**Development Permit Panel
Electronic Meeting**

1. DEVELOPMENT PERMIT 22-023117
(REDMS No. 7844080)

PROPERTY LOCATION: 9511 Granville Avenue

City of
Richmond

Section View of cantilevered slab over critical root zone of Tree #713

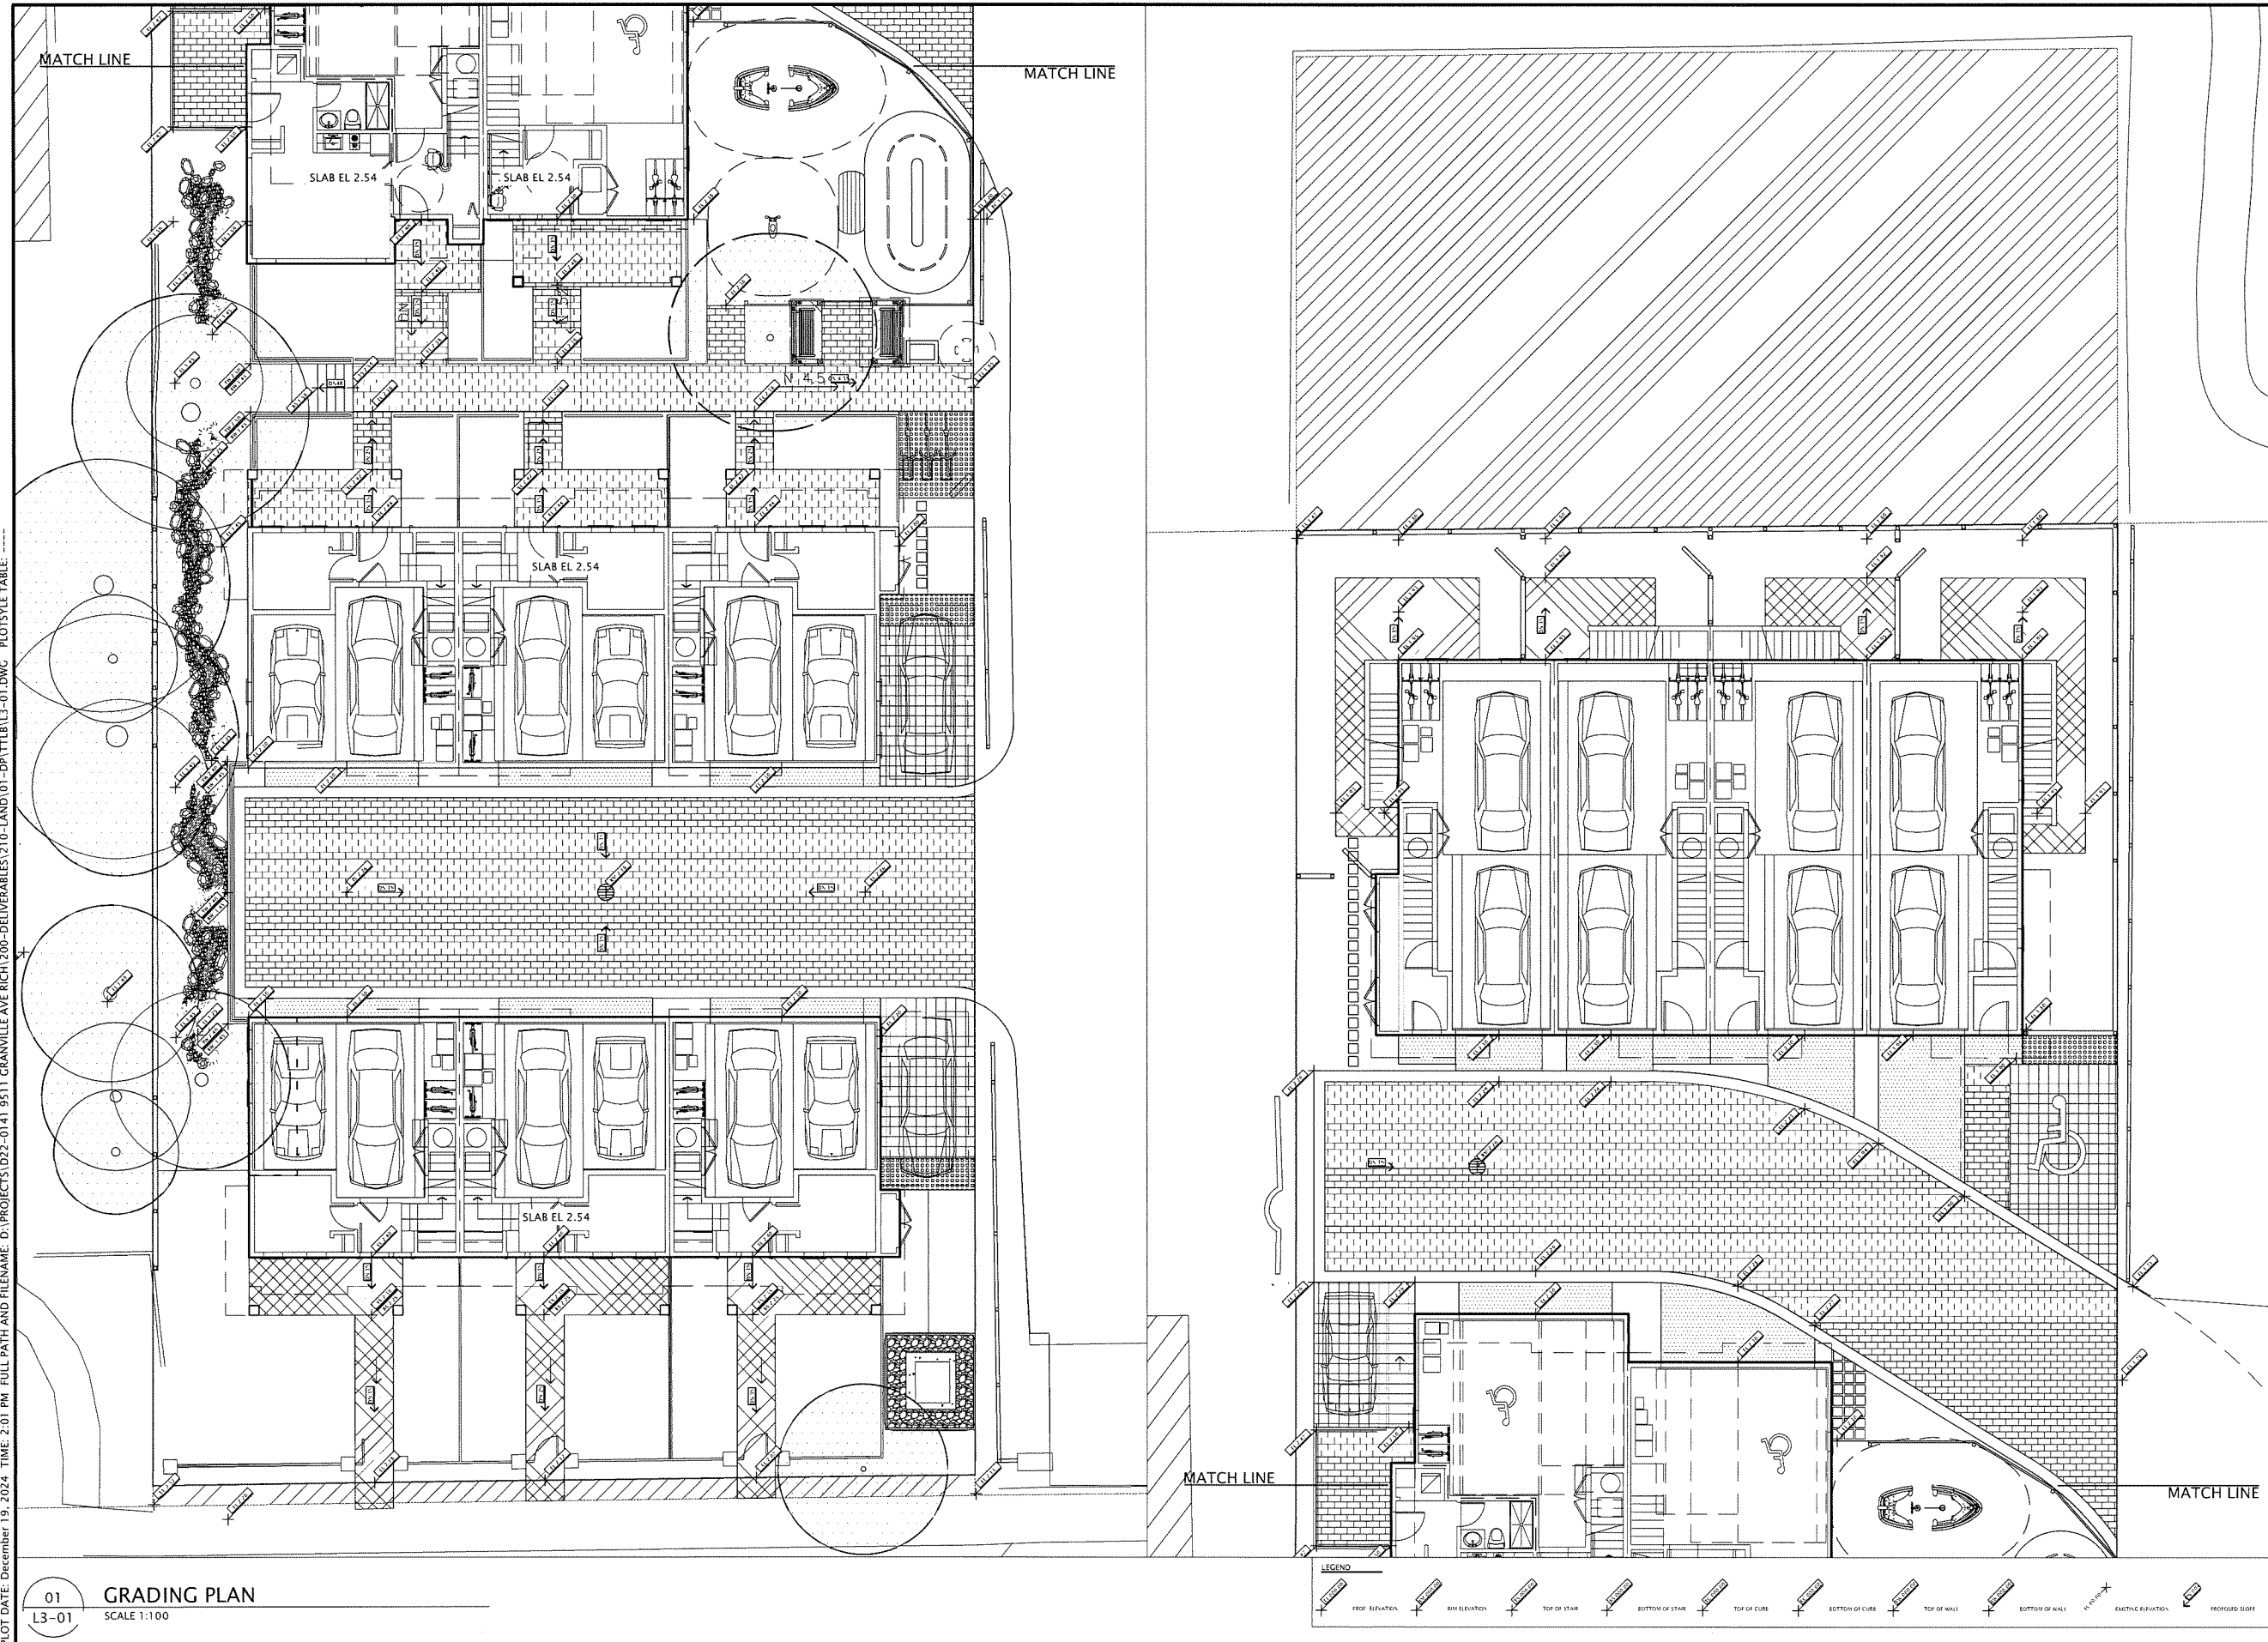
CANTILEVERED SLAB AREA
 To mitigate impact to the critical root zone of Tree #713, the building has been redesigned in this area to reduce excavation requirements for the outer foundation wall. Grading change will be required within the slab area but limited to 8 inches depth below existing grade.
